Origination Form
Proposed Revisions to a Standard Plans Index

Originator:	McGinnis, James	Index Number:	102-120
Date:	5/12/2026	Sheet Number(s):	2, 4, 5
E-mail:	James.McGinnis@dot.state.fl.us	Index Title:	Low Profile Barrier

SETBACK DISTANCE AT DROP-OFFS

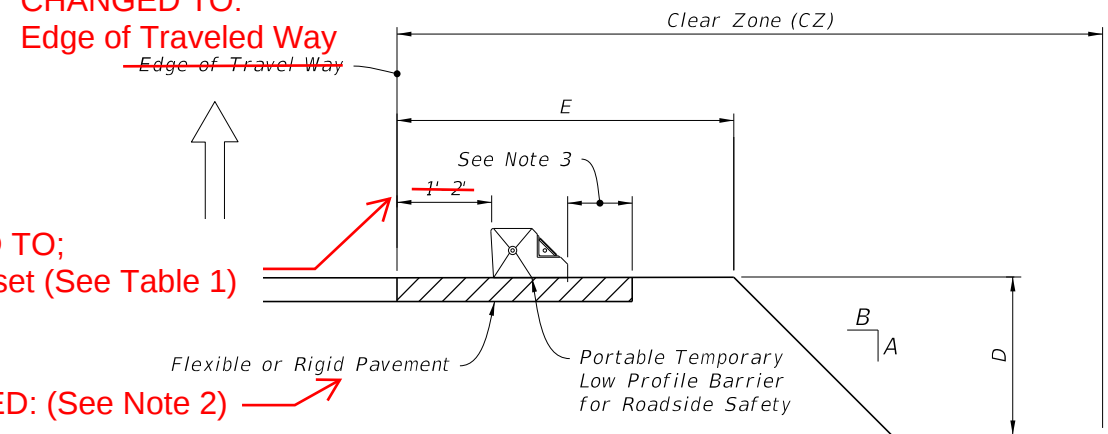
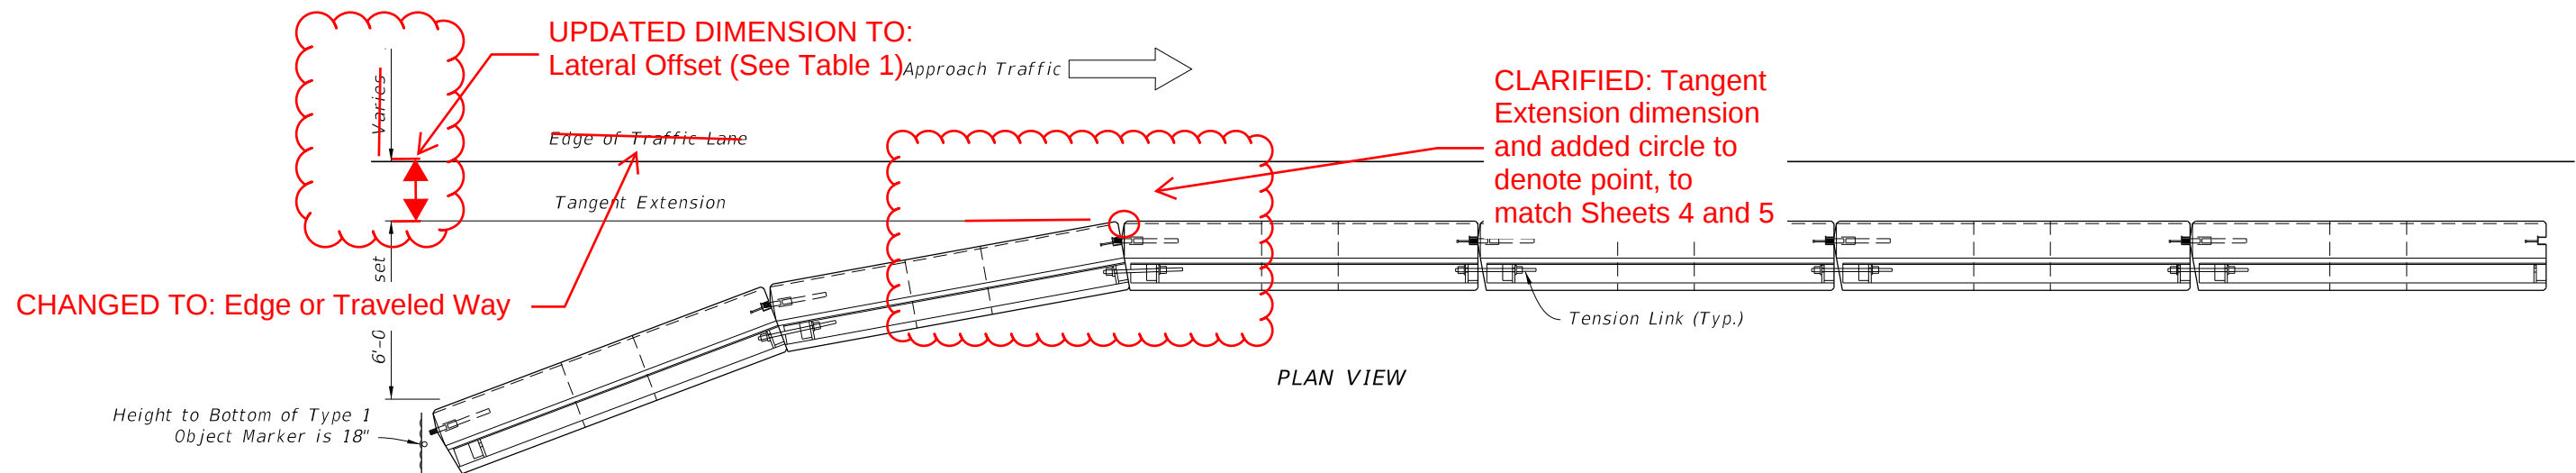
Sheet 2: Changed "Edge of Travel Way" callout to "Edge of Traveled Way"; Changed the "1'-2' " Dimension to a call out "Lateral Offset (See Table 1)"; Added "(See Note 2)" to the Flexible or Rigid Pavement callout in the SETBACK DISTANCE AT DROP-OFFS detail; Updated the "Varies" dimension to "Lateral Offset (See Table 1)", Clarified the Tangent Extension dimension and added circle to denote point, to match Sheets 4 and 5; Changed "Edge of Traffic Lane" to "Edge of Traveled Way in the APPROACH END OFFSET detail; Added title "TABLE 1" to the Table.

ADDED TITLE: TABLE 1

CHANGED TO:
Edge of Traveled Way

CHANGED TO;
Lateral Offset (See Table 1)

ADDED: (See Note 2)

BARRIER OPENINGS AT DRIVEWAYS

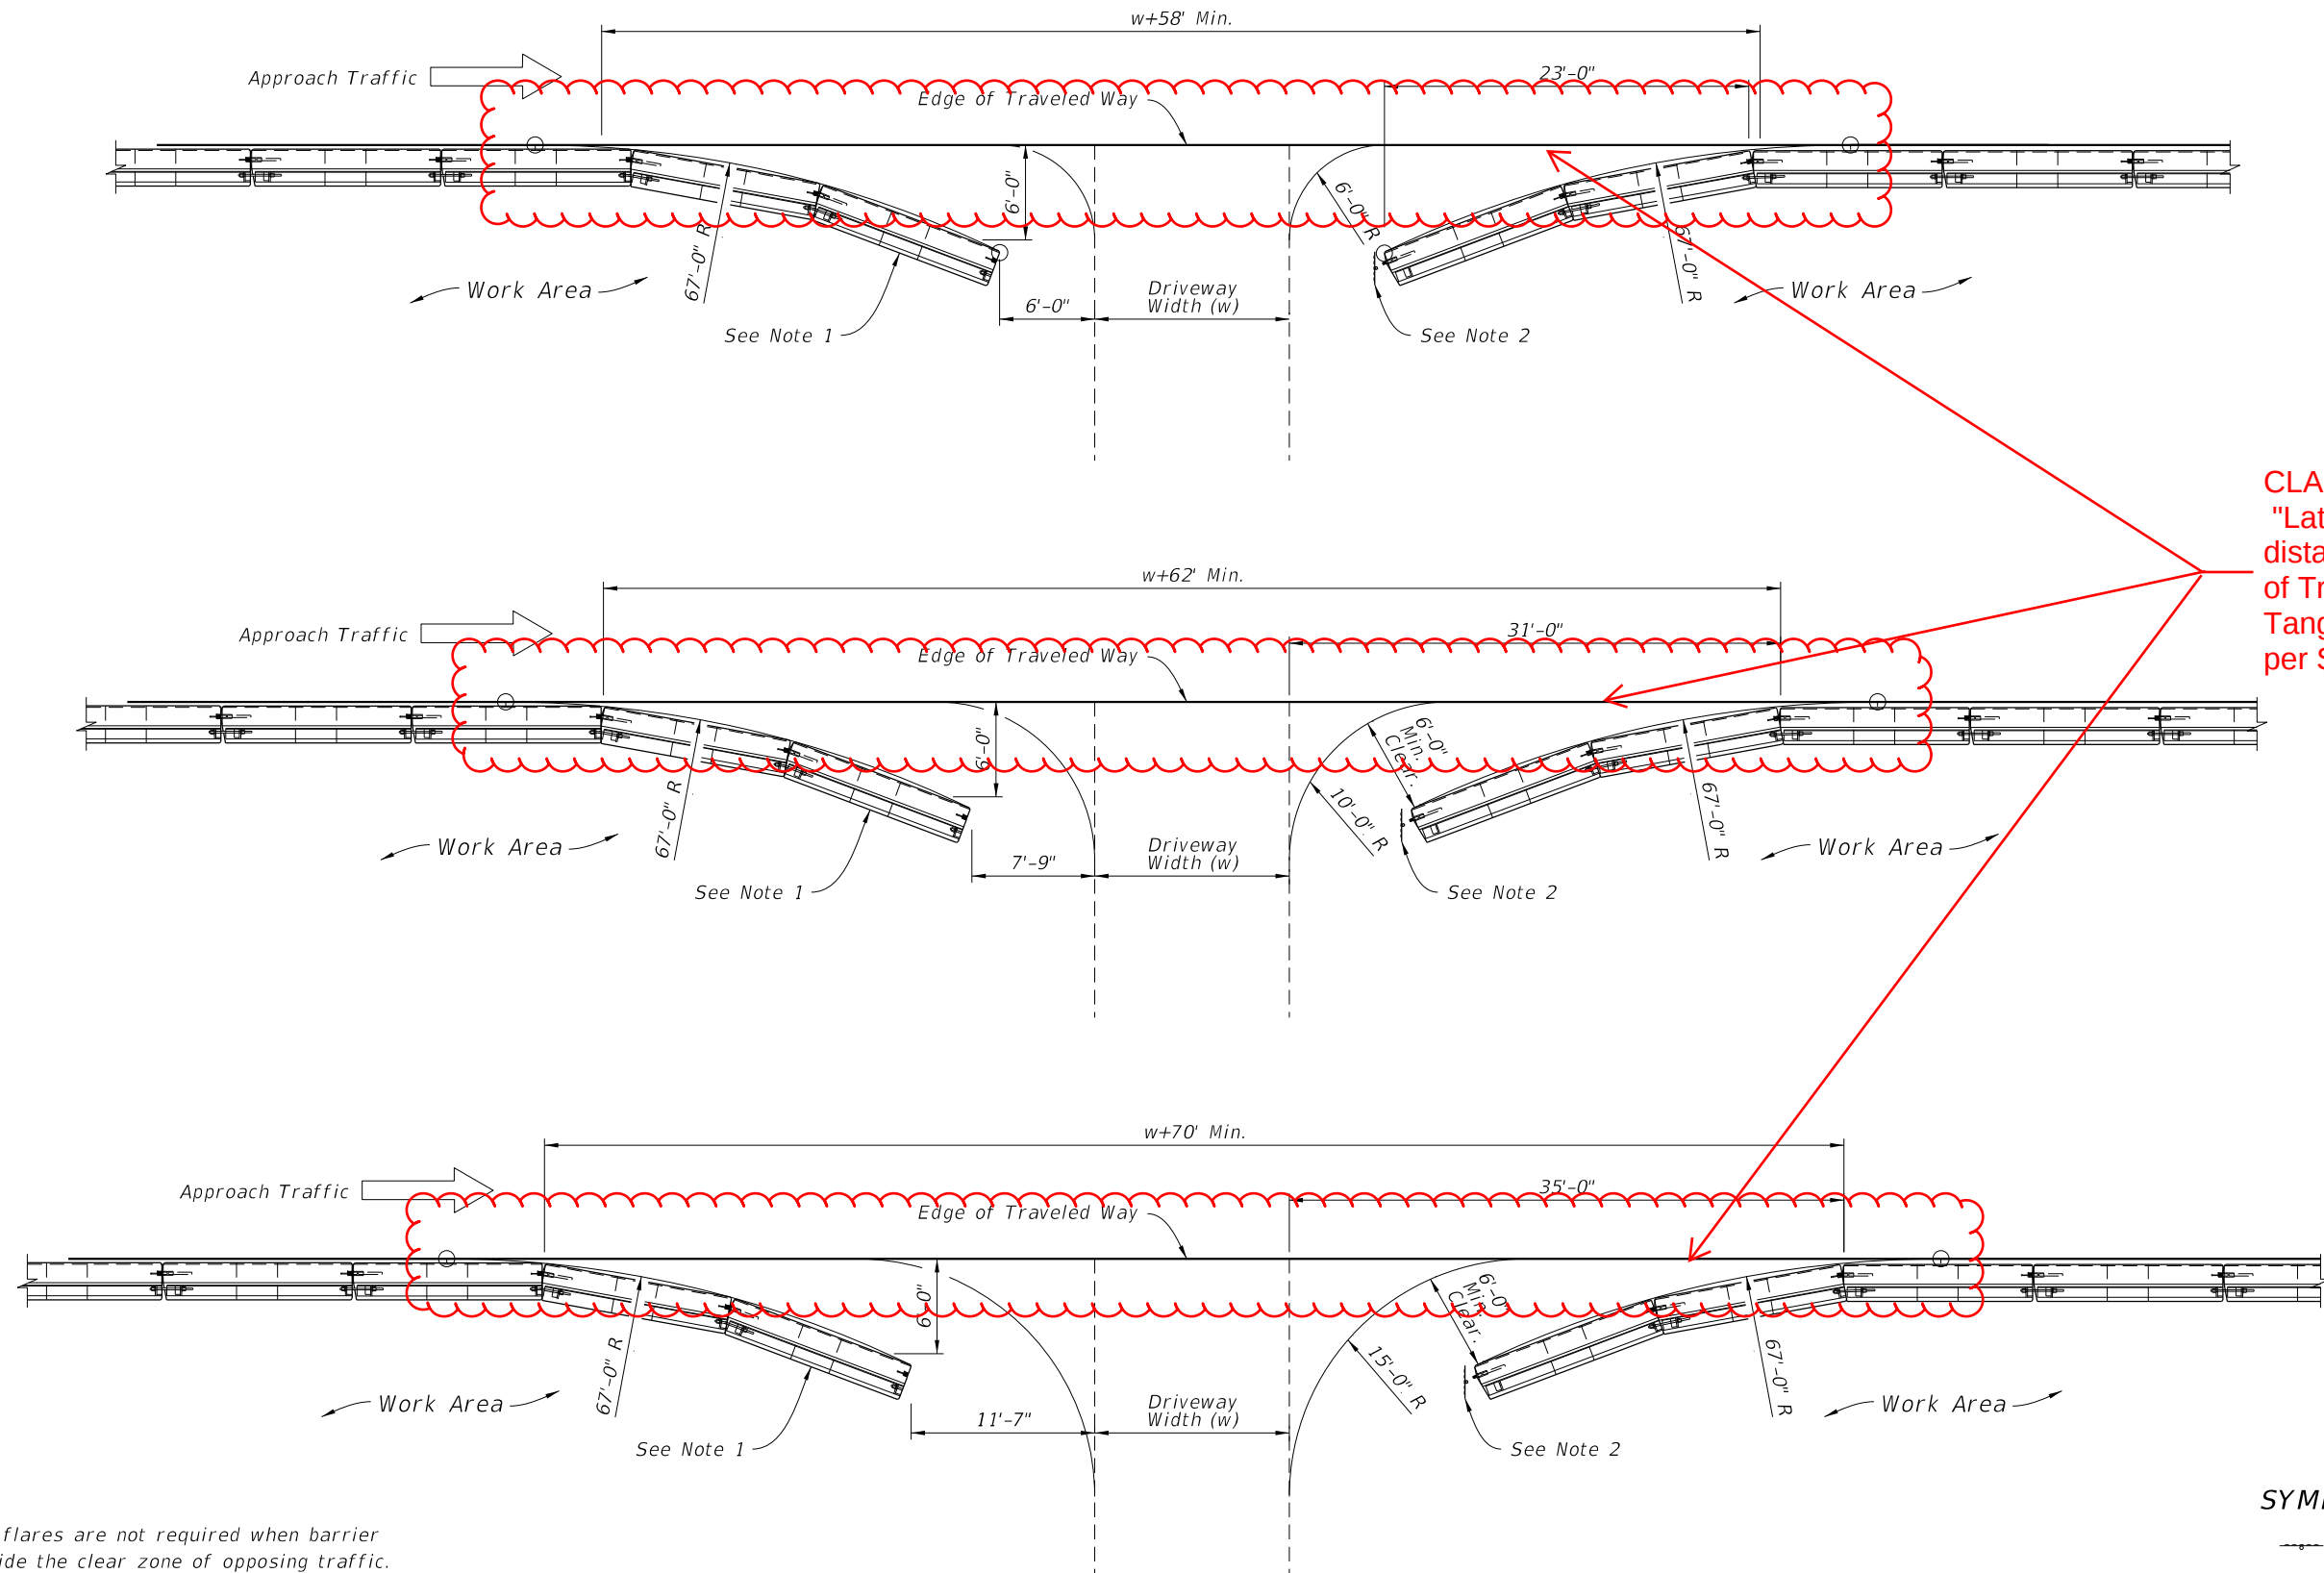
Sheets 4 & 5: In all plan views, clarified the "Lateral Offset" distance between the Edge of Traveled Way and the Tangent Extension Line per Sheet 2.

Districts advised that the details for Barrier Openings at Driveways did not show a large enough Lateral Offset distance between the Edge of Traffic Lane and barrier face, so this caused challenges interpreting the 6-foot measurement. These revisions will now clarify this concept by adding labels and showing the distances to scale.
